North Hertfordshire District Council

Building Conservation comments

File Ref: 24/02748/FPH & 24/02749/LBC

Address: Bibbsworth Hall Farm, Bibbs Hall Lane, Kimpton, Hitchin, Herts SG4 8EN

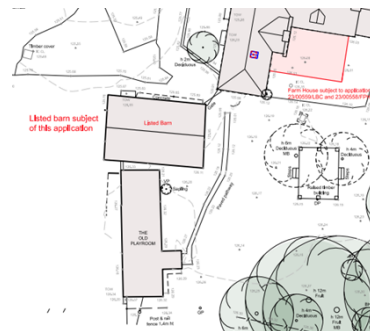
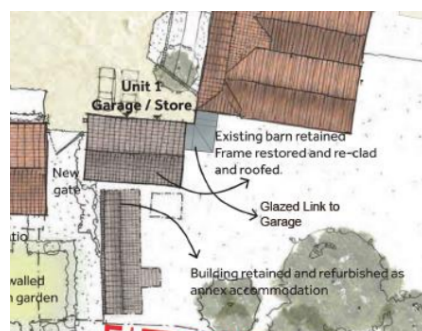
3.6 At my site meeting on 11 February 2025, I did raise the question as to the whether the boarded infill as currently proposed could perhaps be changed to a glazed infill to i) emphasise the separation of both buildings and ii) the benefit of additional light at this transition between both buildings. Unfortunately this suggestion was dismissed by the applicant as maybe unnecessary or impractical.

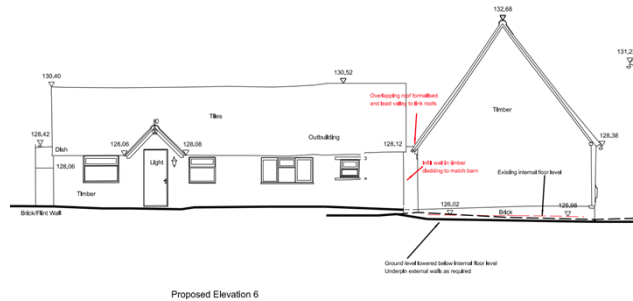
3.3 The building behind the curtilage-listed barn (referred to as 'The Old Playroom' and previously referred to as building B5) was proposed to be retained and left 'unmodified' under ref: 22/02304/PRELB (layout below left). Whilst on 13 October 2023, I commented on refs: 23/01998/FPH and 23/01999/LBC. Under those applications, the curtilage-listed barn remained detached from the building behind (below right).

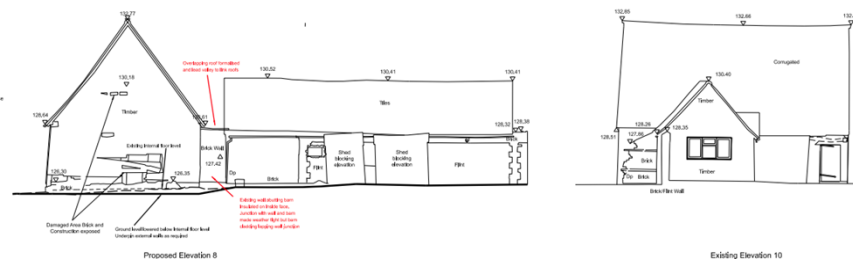
3.4 I have checked the recent planning history, and I cannot find an approved scheme which covers alterations made to building B5. Whilst no objection is raised to making a permanent connection between both buildings it should be noted that Proposed Elevation 6 on drawing no. 24 BIBB P12 (see below), does not reflect the current situation as noted in the photo below that from the Planning and Heritage Statement.

3.5 It may be the case that proposed elevations 8 and 10 also on drawing no. 24 BIBB P12 (see below) also need to be amended but I have no photos available to check this as a desk-top study.

3.7 Having discussed matters with the architect today, it is understood that works to building B5 have apparently been undertaken without consent and that there is a need to regularise alterations made to this building. Not only do the drawings need to be amended accordingly but the descriptions may need to be adjusted to reflect works already undertaken.
